In the woods
8922 Spring Valley Rd. Chevy Chase

Staff Item—Anne Fothergill
May 13, 2009
In the Woods

In March 2009 the HPC approved a new bathhouse and other changes^{to} this community pool, located well behind the historic house. The applicants now need to add a small pumphouse for the wading pool equipment. The materials will match the new bathhouse. Staff is asking the HPC to approve this change to be approved at the staff level.

CHEVY CHASE
RECREATION ASSOCIATION
NEW BATH HOUSE & SITE IMPROVEMENTS
5922 SPRING VALLEY RD CHEVY CHASE, MARYLAND 20815

1
A-1.0
FLOOR PLAN
SCALE: 1/8" = 1'-0"

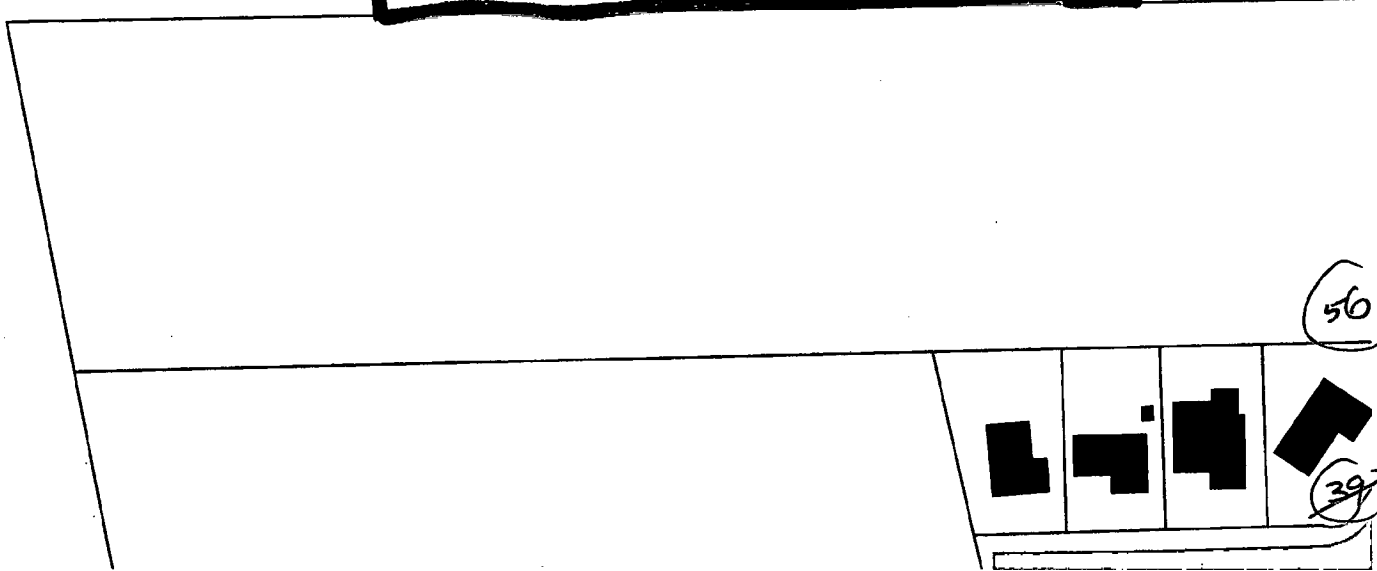
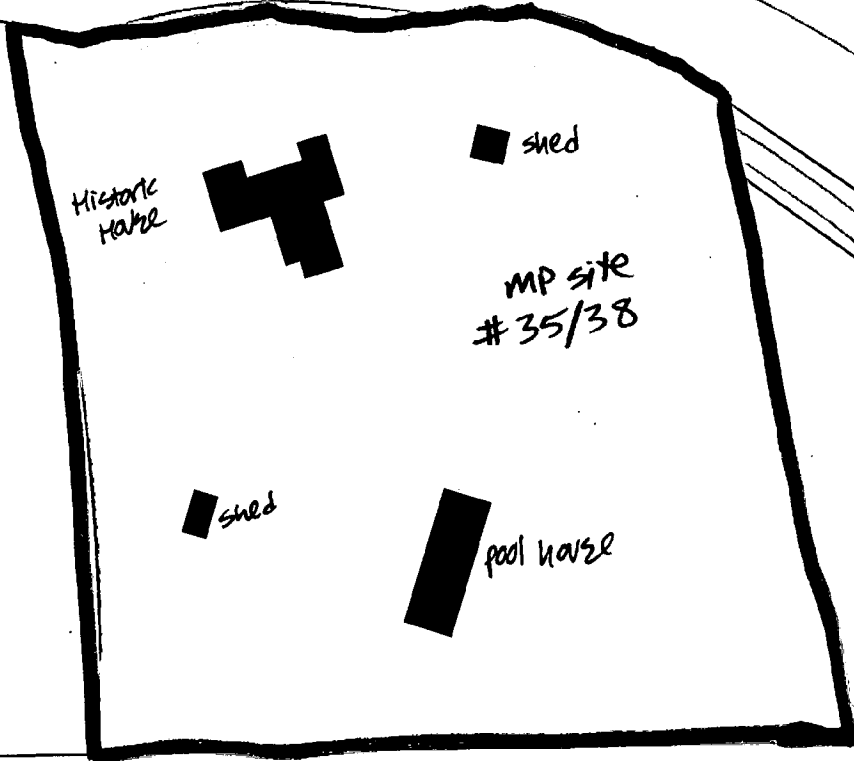
We have to add a small (approx. 10 feet x 12 feet) pump house to the site plan for the new wading pool at CCRA. It will have the same painted cementitious siding and asphalt shingle roof as the main building.

Originally the plan was to sink the equipment in a well or install it at grade with a small enclosure around it, but the warranties that are best to seek for this equipment require a roofed enclosure.
